Access Compliance Report

Public Rights-of-Way

Intersection ID: 30128	Main Street: GALESBURG_ST	Cross Street: WADENA_DR	Location: SE
ADA ID: B3ACDDBF6C16	Ramp Type: BlendTrans2	Initial Pass/Fail: Fail	Overall Compliance: No
		Severity Score: 1.25

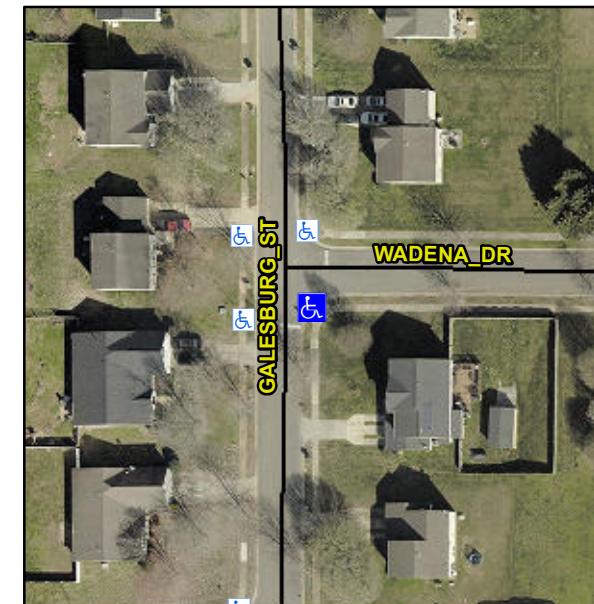
Not Found, R304.5.3

Compliance	Description	Data	Compliance	Description	Data
N/A	Ramp Length (in)	48.0	Yes	BlendTrans Slope (%)	4.7
Yes	Ramp Width (in)	48.0	No	BlendTrans XSlope (%)	2.1
N/A	Flare Type LT	N/A	N/A	Flare Type RT	N/A
N/A	Flare Slope LT (%)	N/A	N/A	Flare Slope RT (%)	N/A
N/A	Flare Traversable LT?	N/A	N/A	Flare Traversable RT?	N/A
N/A	Landing Length (in)	N/A	N/A	DWS Provided?	N/A
N/A	Landing Width (in)	N/A	N/A	DWS Contrast?	N/A
N/A	Landing Slope (%)	N/A	N/A	DWS Length (in)	N/A
N/A	Landing X Slope (%)	N/A	N/A	DWS Full Width?	N/A
N/A	Landing Curb? (Y/N)	N/A	N/A	DWS Offset (in)	N/A
N/A	Shared Landing?	N/A			
N/A	Gutter Ponding?	N/A	N/A	Gutter Slope (%)	N/A
N/A	Gutter Lip Ht (in)	N/A	N/A	Gutter X Slope (%)	N/A
N/A	Painted X Walk1?	No	N/A	Painted X Walk2?	No
	X Walk 1 Direction	To E		X Walk 2 Direction	To N
	X Walk 1 Width (in)	N/A		X Walk 2 Width (in)	N/A
	X Walk 1 Slope (%)	0.4		X Walk 2 Slope (%)	4.1
	X Walk 1 X Slope (%)	1.2		X Walk 2 X Slope (%)	0.1

N/A	Ramp inside XWalk1?	N/A	N/A	Ramp inside XWalk2?	N/A
	Road Slope (%)	2.4		Clear Space?	N/A
	Road X Slope (%)	1.8	N/A	Clear Space to XWalk (in)	N/A
N/A	Any Obstructions?	N/A	N/A	Storm Grate/Utility Hazard?	N/A
	Obstruction Type			Storm Grate/Utility Type	
		N/A			N/A
			Yes	Surface Condition? (G/P)	Good
			No	Curb Slope (%)	16.8

Remove & Replace Curb Ramp With Two New Directional Ramps or Equivalent.
